# City of Ryde

22 September 2011

**EXHIBITION OF ENVIRONMENTAL ASSESSMENT FOR CONCEPT PLAN  
APPLICATION – RESIDENTIAL DEVELOPMENT AT 74 - 76 BELMORE  
STREET, RYDE (MP10\_0110)**

Figure 1.1

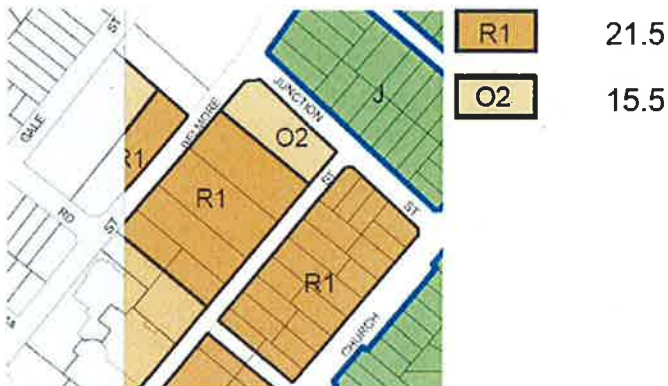
The heights proposed under the RELP 2011 provide a maximum height limit of 21.5m for the majority of the site and a height limit of 15.5m for the north-most allotment within the subject area, as detailed within Figure 1.1. Generally, Council is of the opinion that a height limit of 21.5m provides a maximum height of 6 storeys and that a height of 15.5m provides a height of 4 storeys.

**Given the above, it is recommended that the height limit of the Concept Plan not exceed Council's proposed height controls of 21.5m and 15.5m.**

**Figure 1.2**

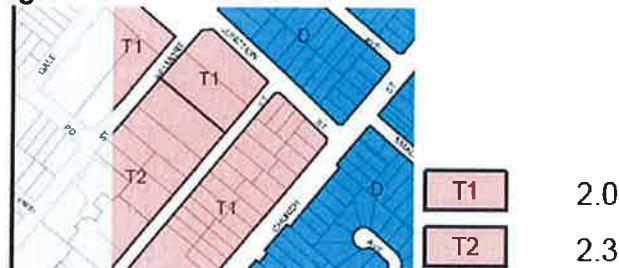
It should be noted that the RLEP 2011 provides a Floor Space Ratio (FSR) of 2.0:1 and 2.3:1 on the subject site. The position of these FSR are identified in Figure 1.2 below.

Given the relatively high level nature of the proposed Concept Plan and that no buildings are proposed at this time, **it is recommended that compliance with the requirements of Council proposed controls is imposed on future development.**
